[Docket No. FAA-2016-4228; Directorate Identifier 2015-NM-107-AD; Amendment 39-18734; AD 2016-25-08]

Airworthiness Directives; Airbus Airplanes

ACTION: Final rule.

Figure 1 to Paragraph (i)(7) of this AD – Design A of the Passenger Oxygen Containers Affected by this AD

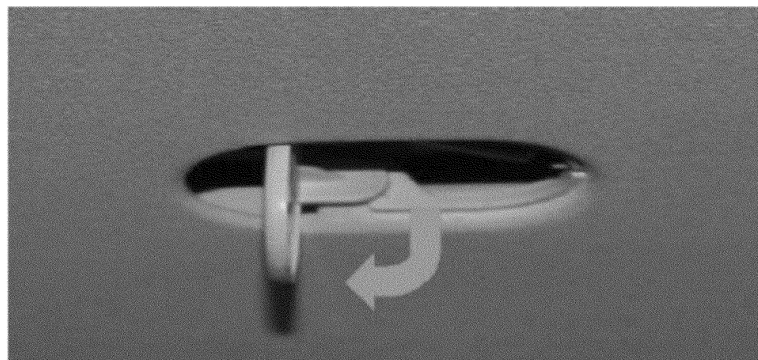
(7) The requirements of paragraphs (g) and (h) of this AD apply only to passenger oxygen containers that are Design A, as defined in figure 1 to paragraph (i)(7) of this AD.

Design A: The placard on the passenger oxygen container test button is as described in Picture A of Appendix 1 of this AD. The Mask configuration ("ZZ" in Picture A) is a number and the test button is as shown in Picture B.
